RE: Summary of Modifications
21-DR-2002#2
Vargo Quarter Horses (VQHS)
3474C (Key Code)

Project Narrative

Re: 53-PA-2023
21-DR-2002#2

CASE# 21-DR-2002#2

ROOF OVER TOPOGRAPHY PLAN

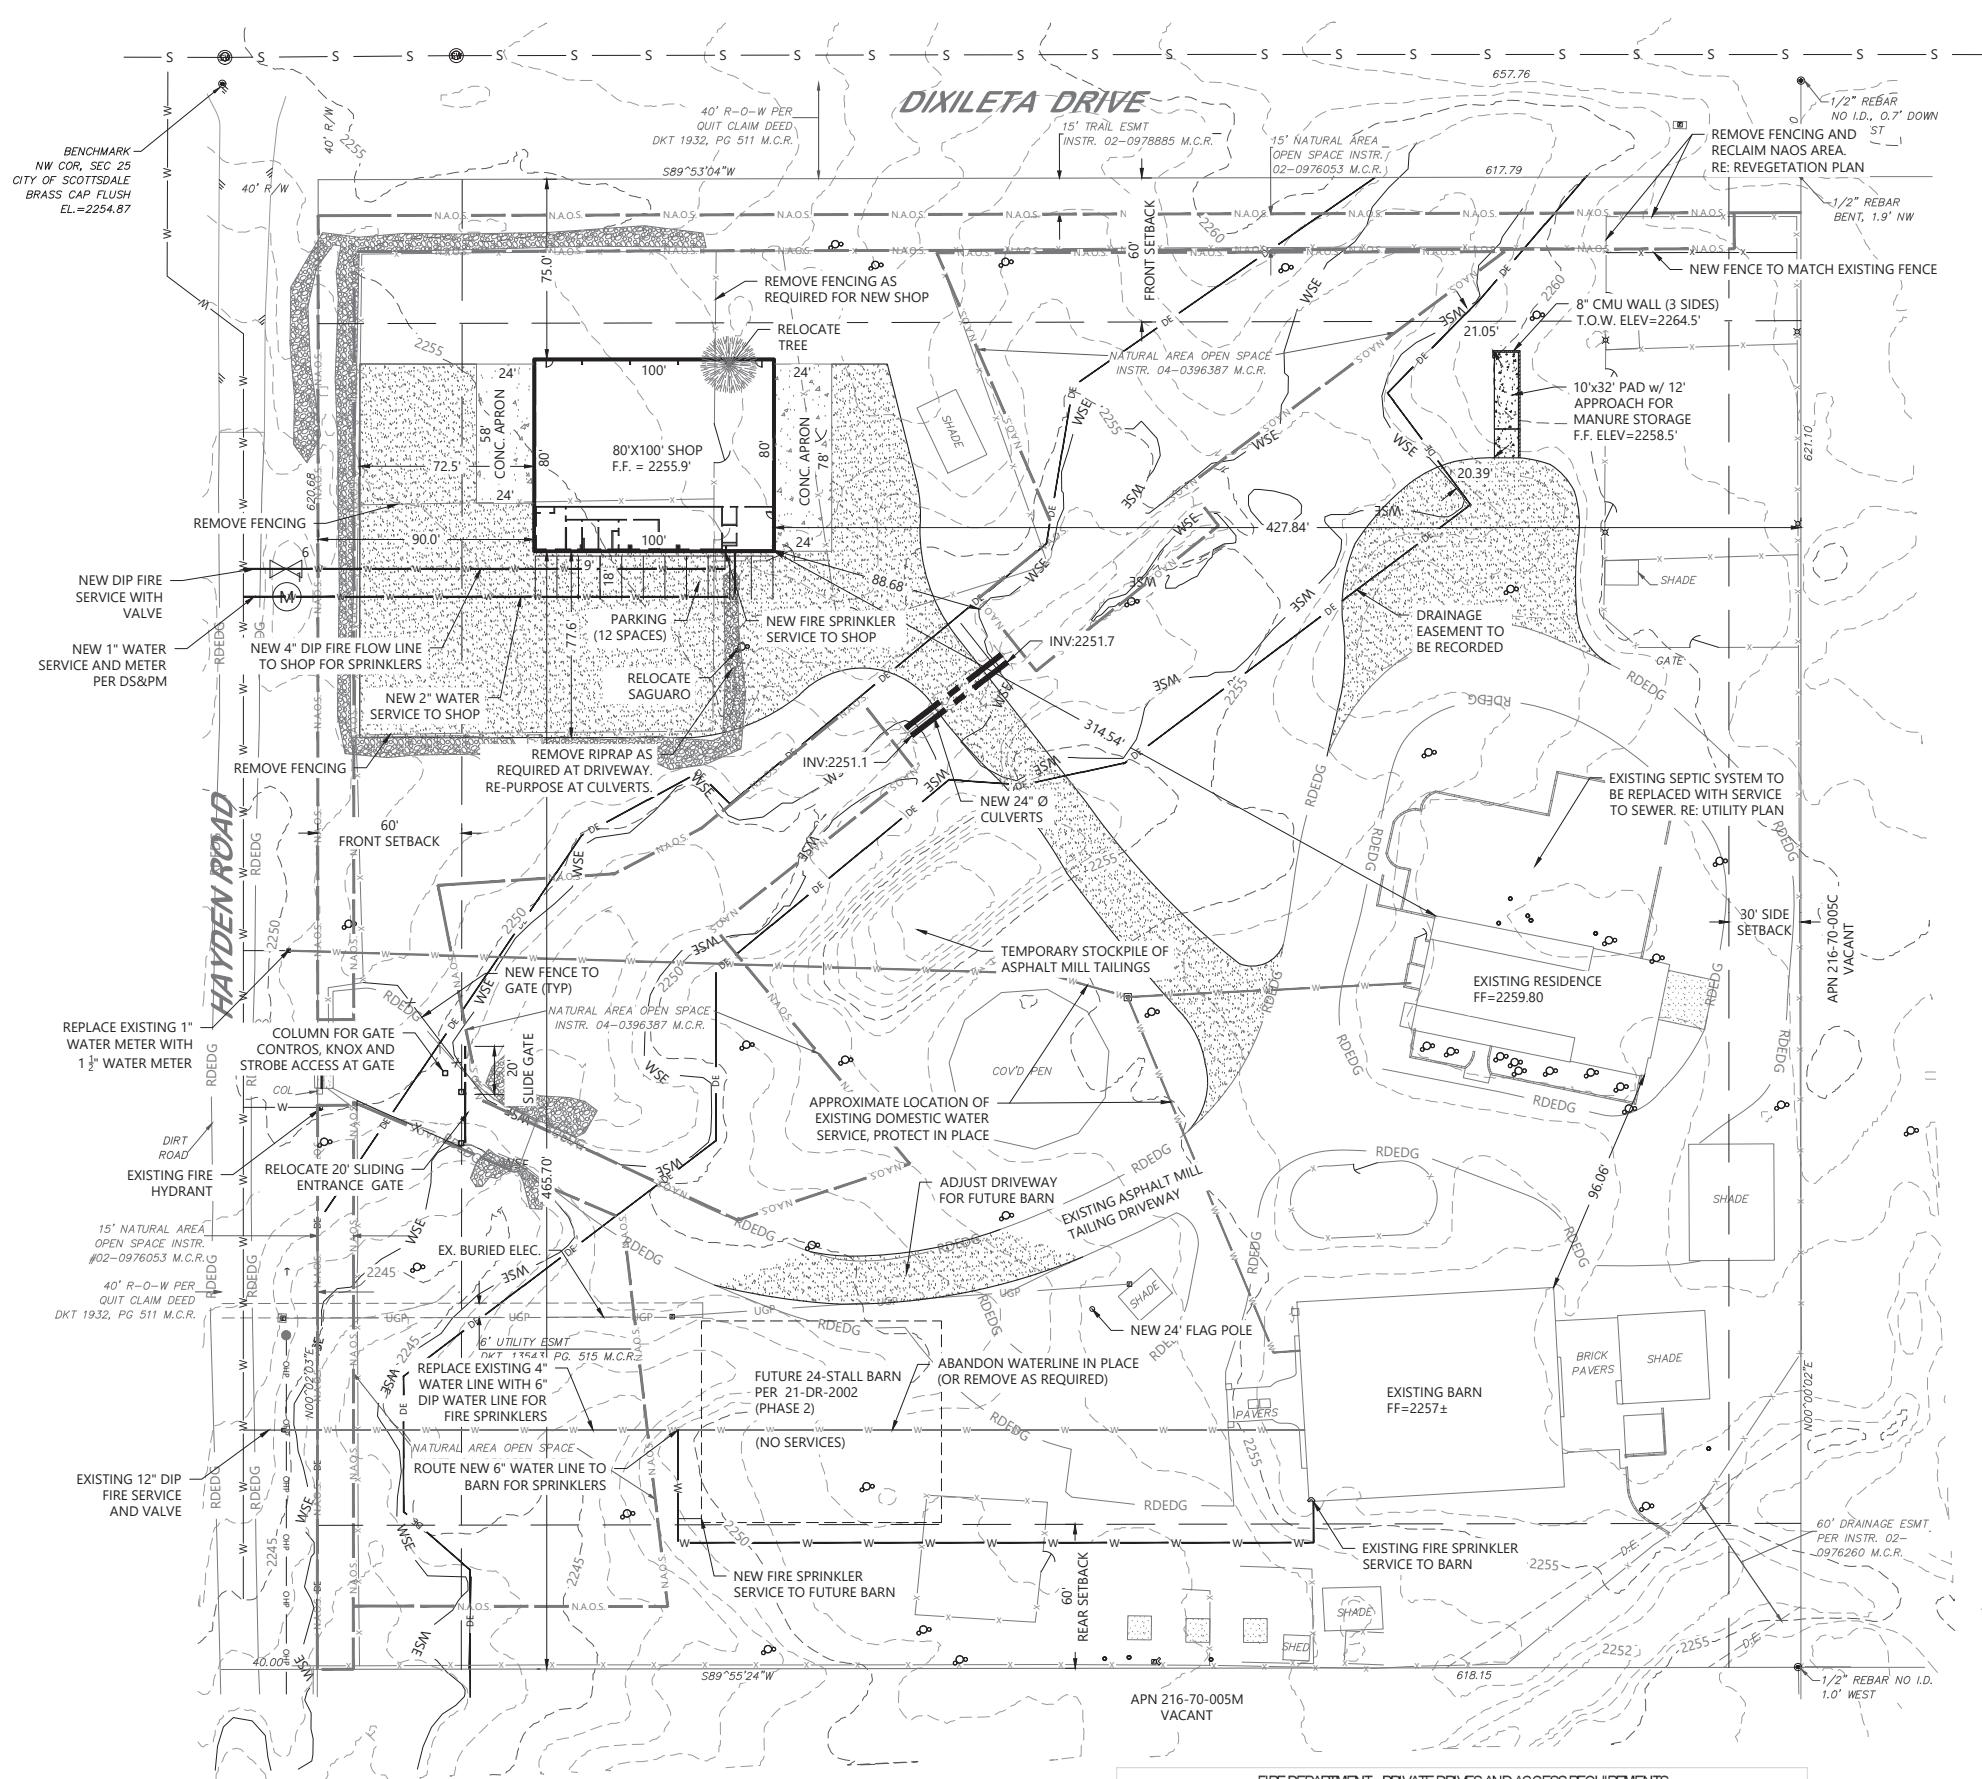
1. Changes to the site plan include moving the proposed shop due to revisions to the Drainage Report. The Q-100 peak design flows derived for the existing wash that enters the property at the north boundary and discharges at the southwest corner of the site was revised based on hydrology modeling resulting in a flow greater than 50 CFS. This existing location of the shop from the first submittal encroached on the water surface elevation of the Q=100 peak storm event. We have revised the shop location to the northwest corner of the site to meet required setback distances to the wash. In addition, a drainage easement is proposed as necessary per the DSPM. Associated items that were revised with moving the shop location include revising grading, driveway access, manure refuse location, and adding driveway access for refuse collection.

2. Revisions to the Building Elevations were made to meet the maximum building height from undisturbed grade. The building was revised from 24' tall to 22.5' tall and a roof over topography plan was added to the site plan.

PHOTOMETRIC PLAN

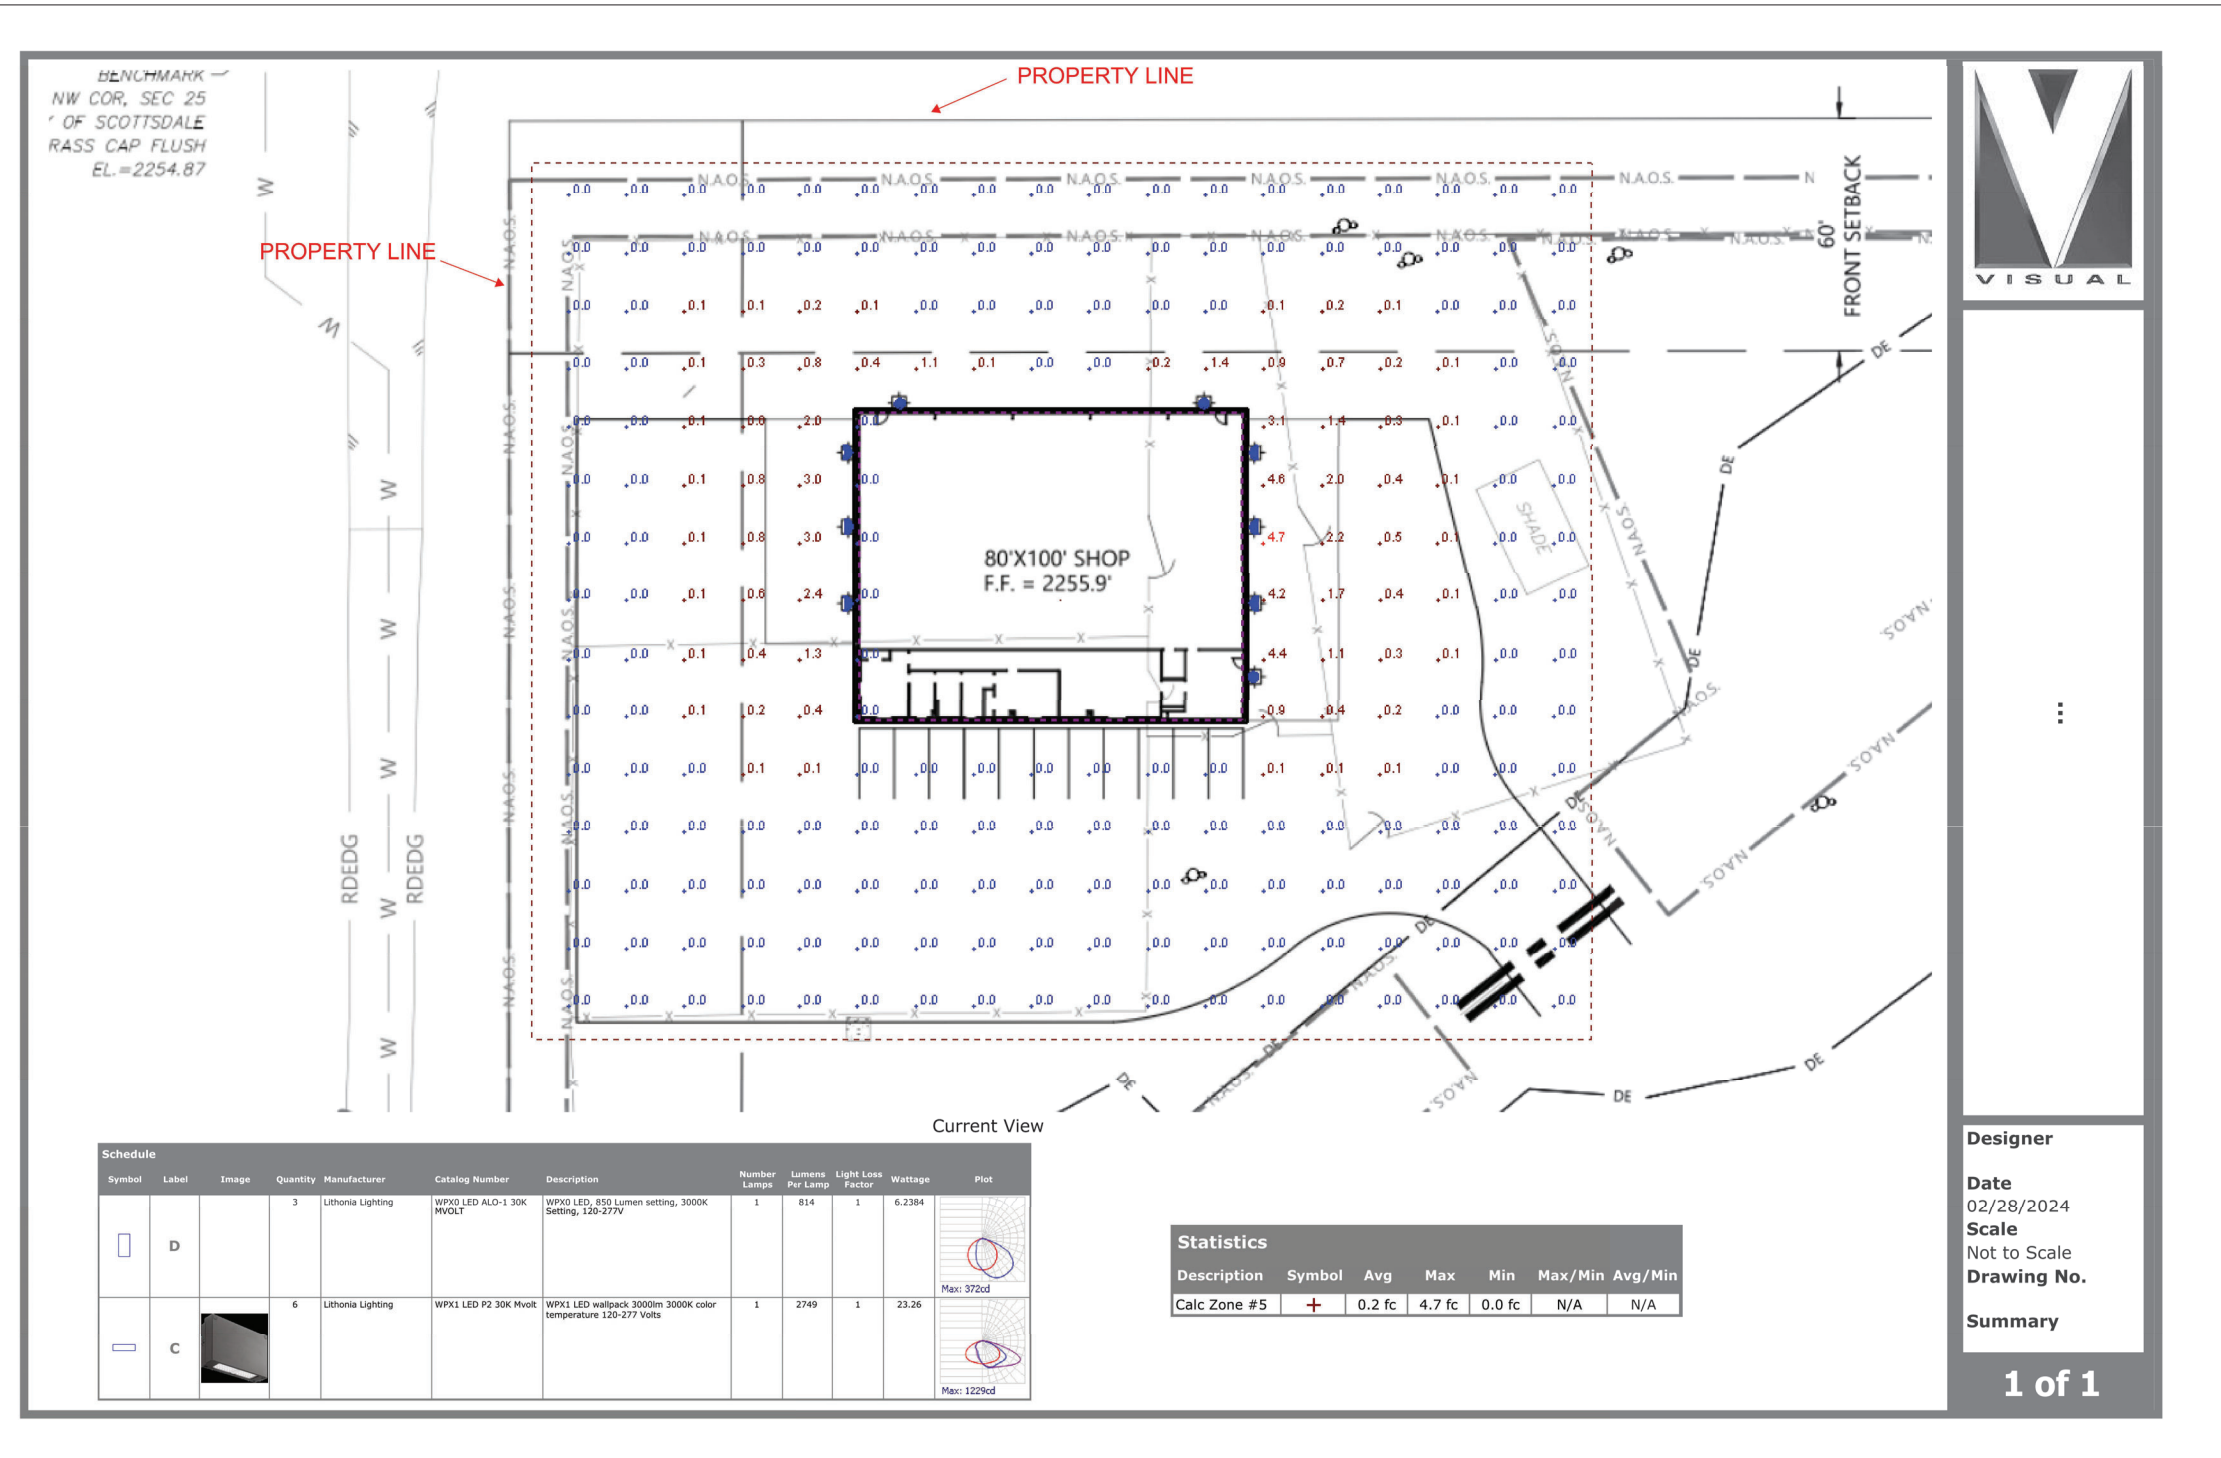
6. Exterior lighting fixtures were revised to meet the City of Scottsdale Exterior Lighting Policy and updated photometrics and cut sheets were provided based on light fixtures and new shop
